Regarding: Grove Street Residences – 121 Grove Street
MassDEP File No. 159-1286
Notice of Intent Peer Review

RJ O’Connell & Associates (RJOC) and Lucas Environmental (LE) have reviewed the comments issued by BETA Group, Inc. (BETA) dated February 20, 2024, and have prepared responses in this letter and included attachments, as necessary.

RJO'CONNELL & ASSOCIATES, INC.
 CIVIL ENGINEERS, SURVEYORS & LAND PLANNERS
 DATE: 12/18/2023 SCALE: 1"=160'
 REVISED: 03/28/2024
 GROVE STREET RESIDENCES
WETLAND & BUFFER ZONE IMPACT EXHIBIT
 121 GROVE STREET
 FRANKLIN, MA

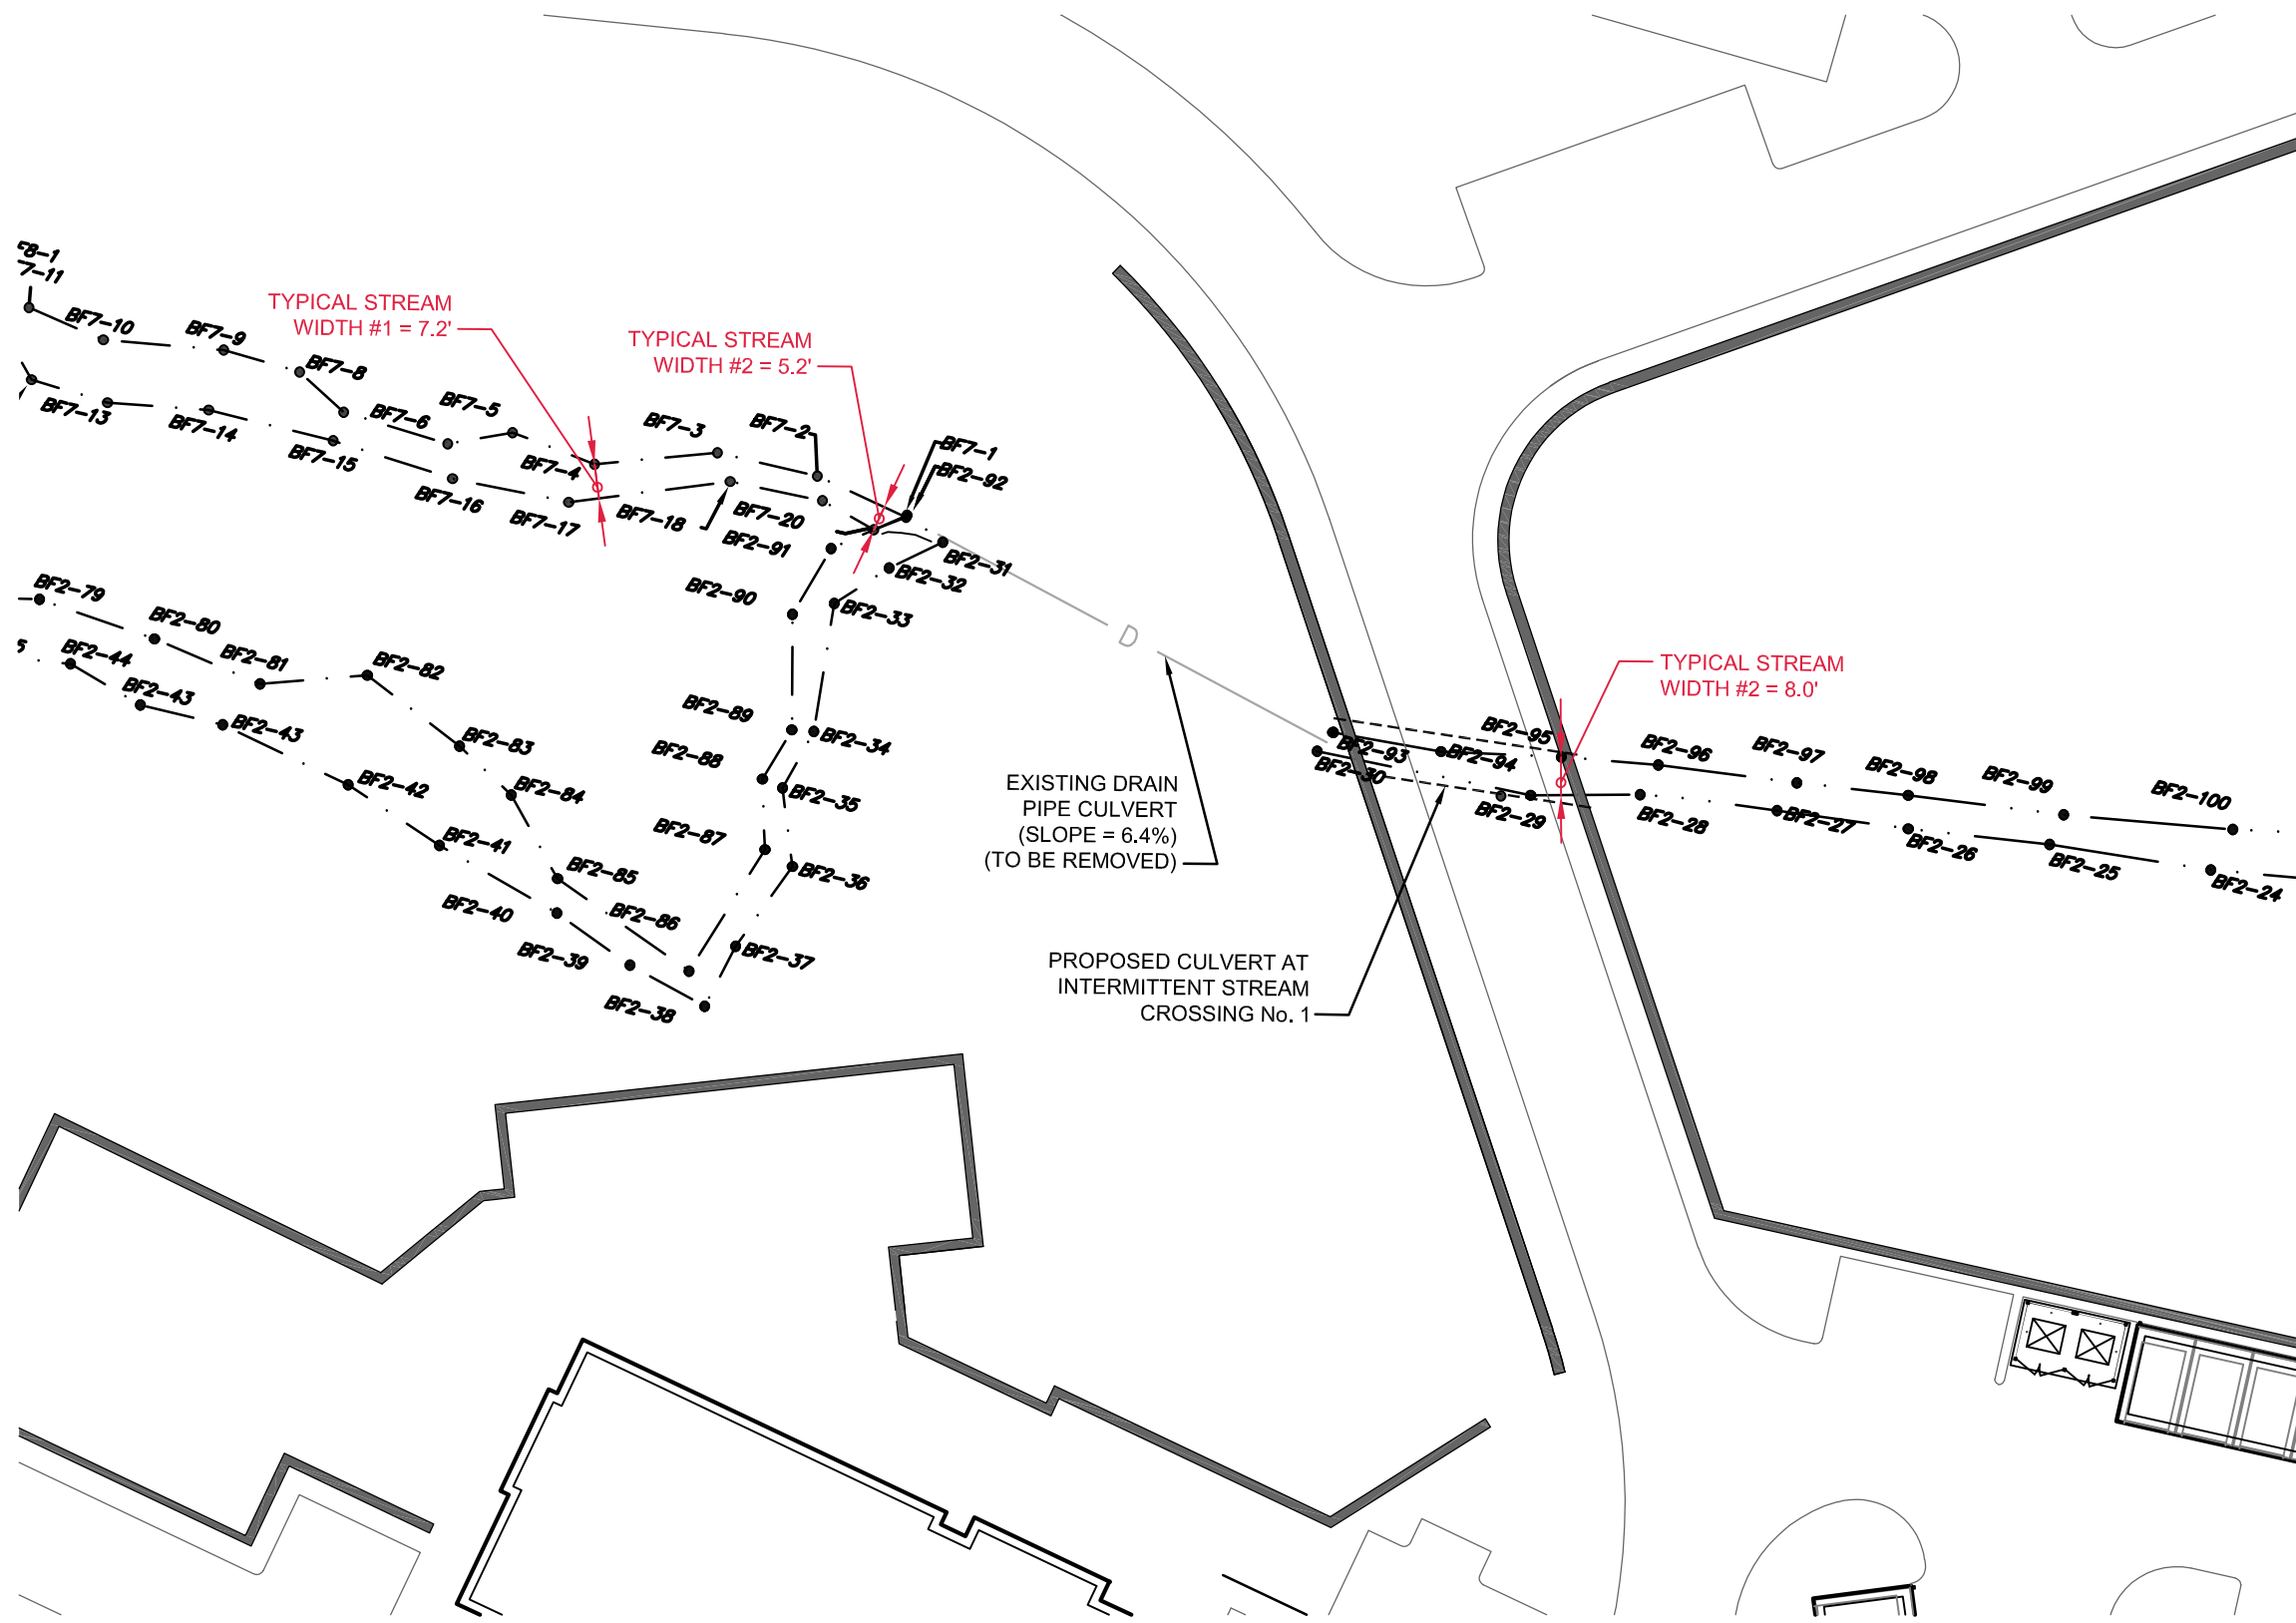
- c. *Erosion controls are depicted directly adjacent to the proposed retaining upgradient of the BVW near the proposed pool and clubhouse, and within Buffer Zone north of Building #3. Considering that over excavation is required to set the footings for segmented block walls, additional temporary BVW/Buffer Zone impacts are likely to be required at these locations and the limits of work do not appear to represent a constructable Project. The Applicant should revise the limits of work and disclose all impacts accordingly.*

W10. *The “Existing Wetland Disturbance Exhibit” depicts areas of existing disturbed wetlands (12,485 sf) resulting from active mowing that will be restored as a part of the Project. A portion of the proposed restoration (as depicted by the Applicant) will be permanently impacted through construction of the clubhouse pool. Similarly, a portion of the proposed Boardwalk #2 is also within proposed BVW restoration area. Revise the Exhibit and restoration totals accordingly or adjust the limits of work.*

The limits of work have been revised, as necessary, and the temporary/permanent BVW impact calculations have been updated as depicted on the Wetland & Buffer Zone Impact Exhibit in Attachment #3 of this response letter.

Response: The proposed retaining wall adjacent to the clubhouse pool has been revised to avoid both temporary and permanent impacts to the wetland. The existing, disturbed wetland areas will be restored via tilling and seeding, and immediately covered with a straw mat for erosion and sediment control. The disturbed wetland areas to be restored at Boardwalk #2 will be seeded below the boardwalk for restoration, however there will be footings installed within this area that will have an overall impact of approximately 5 sf. Therefore, there will be an overall wetland restoration area of 12,480 sf.
